***Docket Item #8  
Development Special Use Permit with Site Plan  
#2007-0006  
McDonalds Restaurant – 5311 Duke Street***

<b>Application</b>	<b>General Data</b>
<b>Project Name:</b> <b>McDonald's Restaurant</b>	Planning Comm. Hearing: November 6, 2008
	City Council Hearing: November 15, 2008
	If approved, DSUP Exp. May 5, 2010 (18 mths.)
	Plan Acreage: 0.66
<b>Location:</b> <b>5311 Duke Street</b>	Zone: CG
	Dwelling Units: N/A
	Gross Floor Area: 3,908
<b>Applicant/Address:</b> McDonald's USA, LLC by M. Catherine Puskar 690 Rockledge Drive, Suite 1100 Bethesda, MD 20817	Small Area Plan: Landmark/Van Dorn
	Proposed Use: Restaurant with Drive-through
	Historic District: N/A
	Green Building: LEED Credits

**DSUP #2007-0006**

Figure 1. Proposed site plan

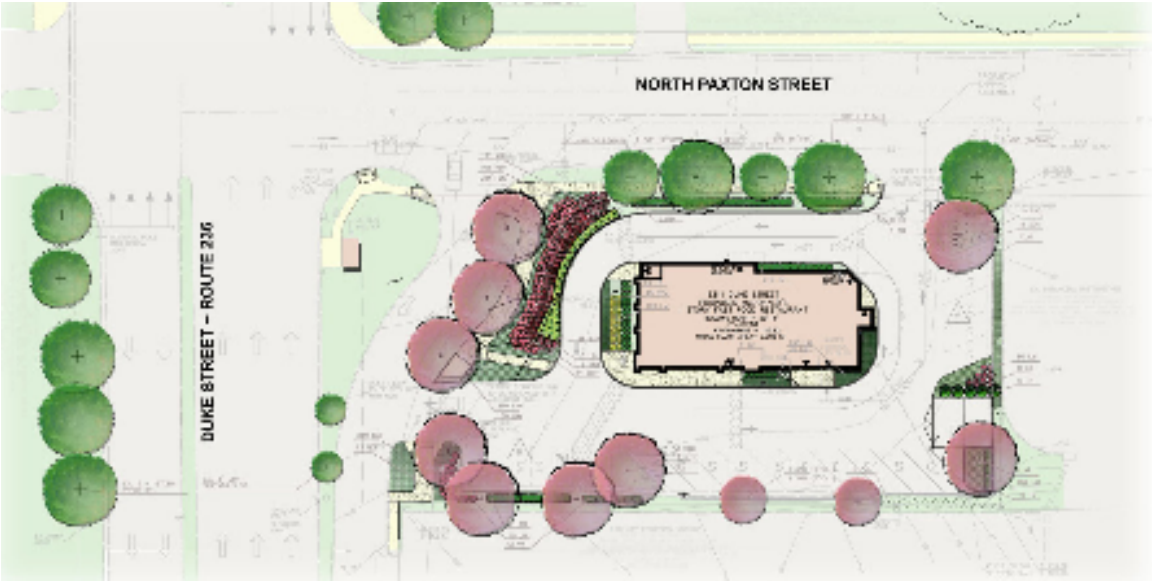
15. Landscape plan shall be generally as depicted in the Preliminary plan with the exception of the conditioned modifications. The following modifications to the landscape plan and supporting drawings are required:

- a. Show landscape plan at a scale of 1" = 10'.
  - b. Clearly depict property line boundary.
  - c. As drawn, it appears that some legend symbols are missing. Correctly display legend on landscape sheet.

- d. Provide City Standard notes on landscape sheet as set forth in the City of Alexandria Landscape Guidelines.
  - e. Provide a screen hedge along the north property line. Modify existing lirioppe to create a buffer between screen hedge and parking lot such that overhanging cars do not damage shrubs.

- f. Remove maple trees on the east property line.
  - g. Replace retaining wall along east property line with a permanently constructed wall.
  - h. Remove flowering cherry tree along N. Paxton Street and replace with *Quercus phellos*. (RPCA)
